Historical Radiological Assessment – Supplemental Technical Memorandum

**Naval Station Treasure Island
San Francisco, California**

July 1, 2014

Photo 7 Showing sanitary sewer line in 1946 drawing

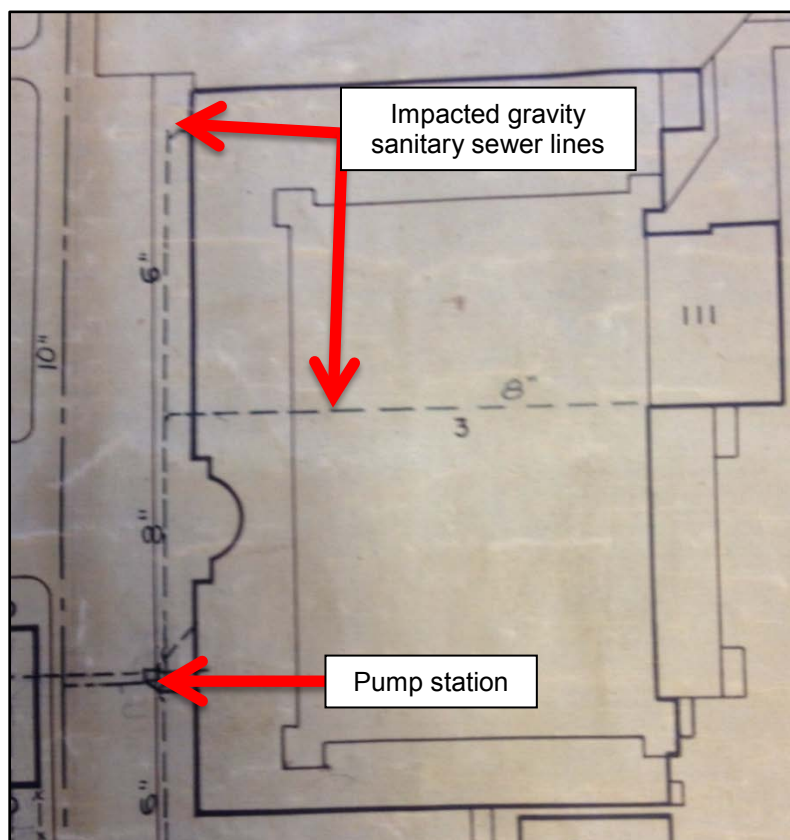
3. **Comment:** Page 10: Photos 6 and 7 appear to have inconsistent orientation. Please correct or clarify if so.

Response: Photo 7 has been rotated 90 degrees counterclockwise to provide consistent orientation as requested.

FIGURE 12
REPAIR/SOLID WASTE DISPOSAL
OPERATIONS –
CONCEPTUAL SITE MODEL

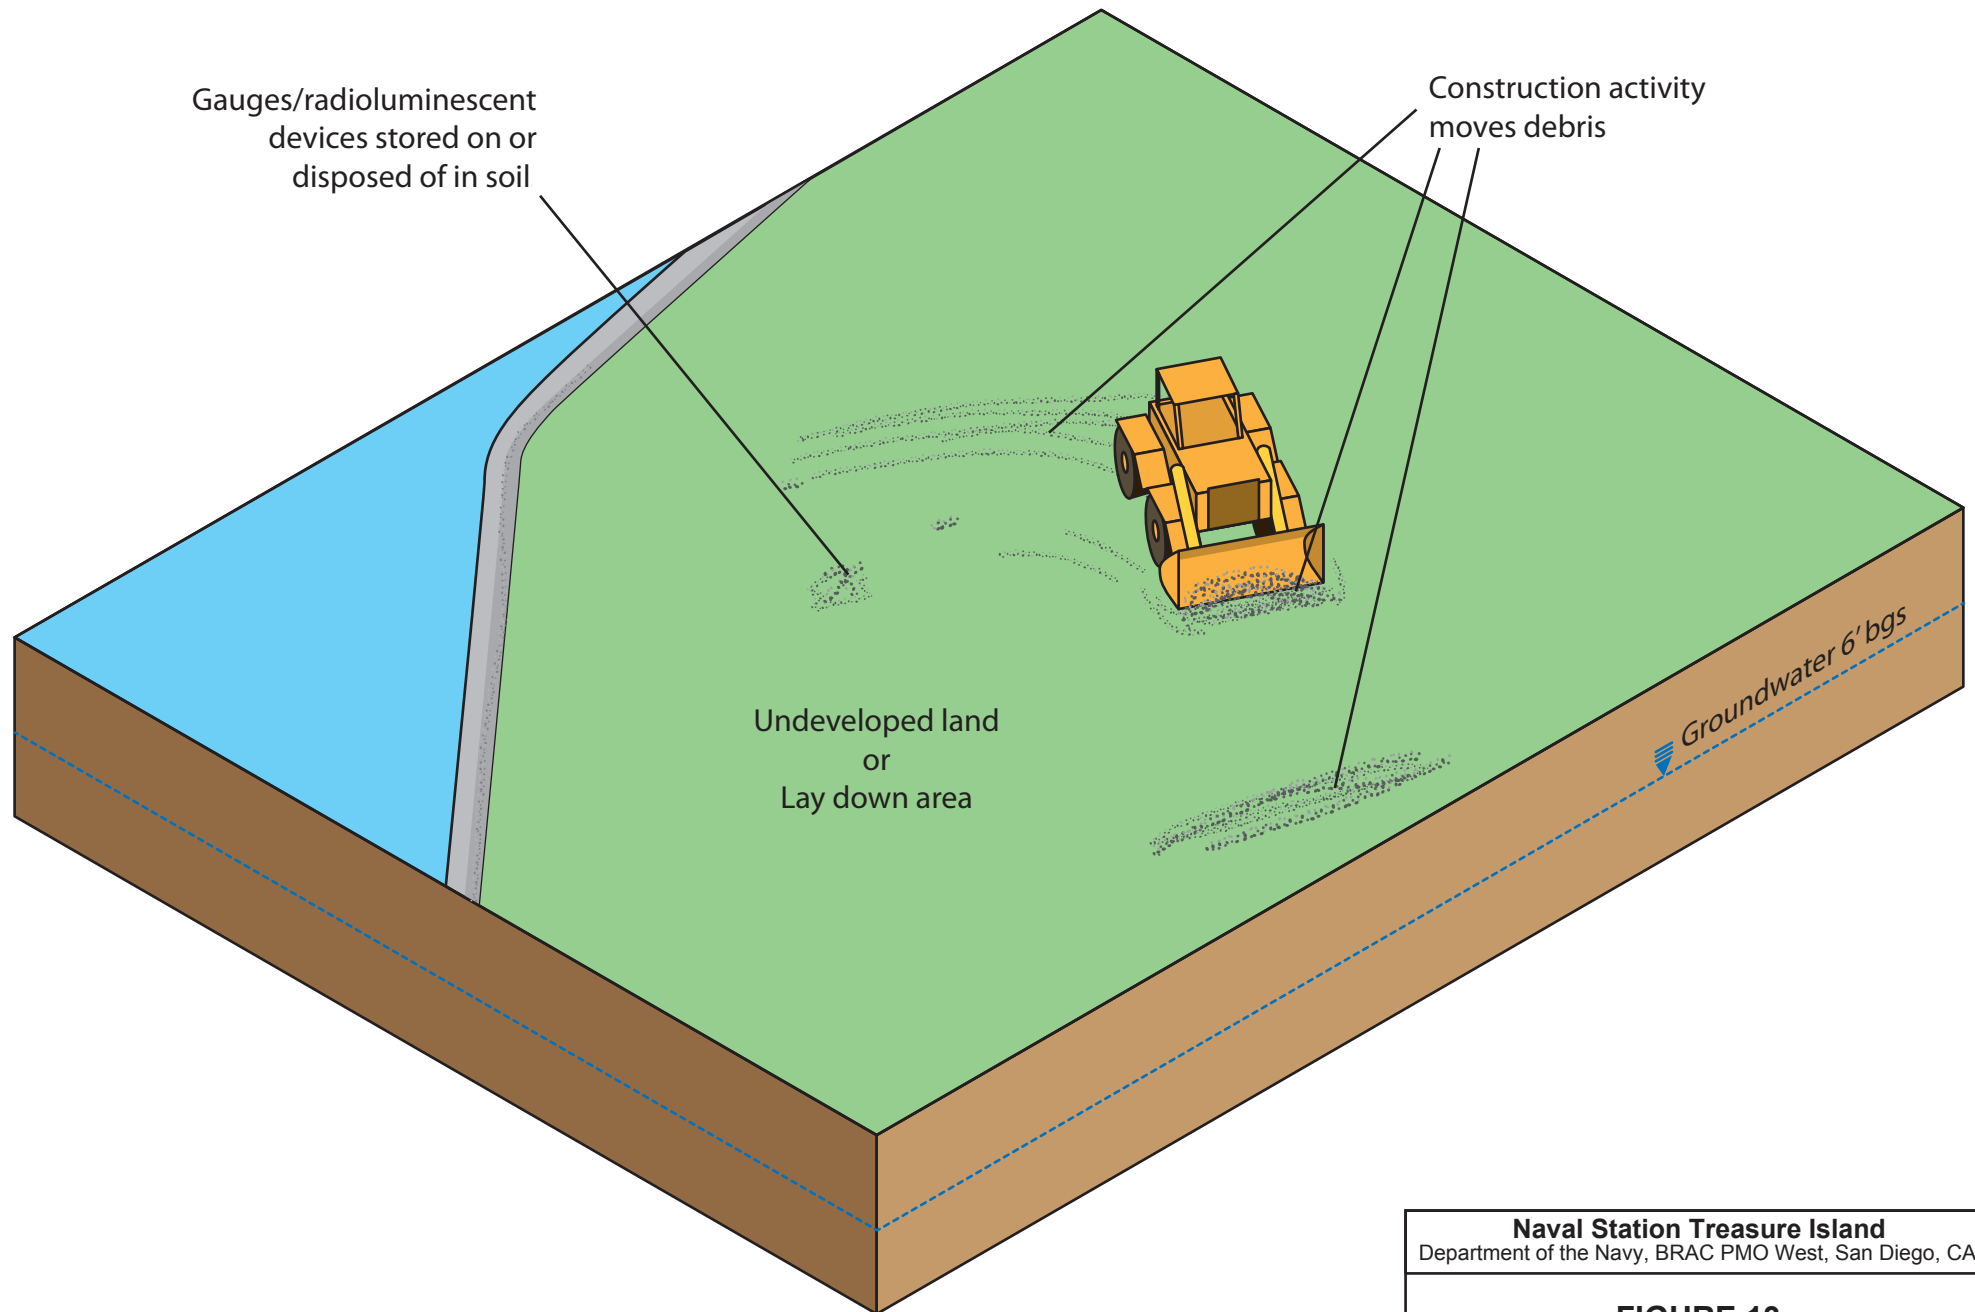
17. **Comment:** Section 5.2.1 and Figure 11: It does not seem appropriate to limit disposal (inadvertent or otherwise) of commodities to known salvage yards. Also, suggest revising the transport pathway to read “near-surface disposal.”

Response: Figure 11 was revised to read “Near Surface Disposal” as suggested.
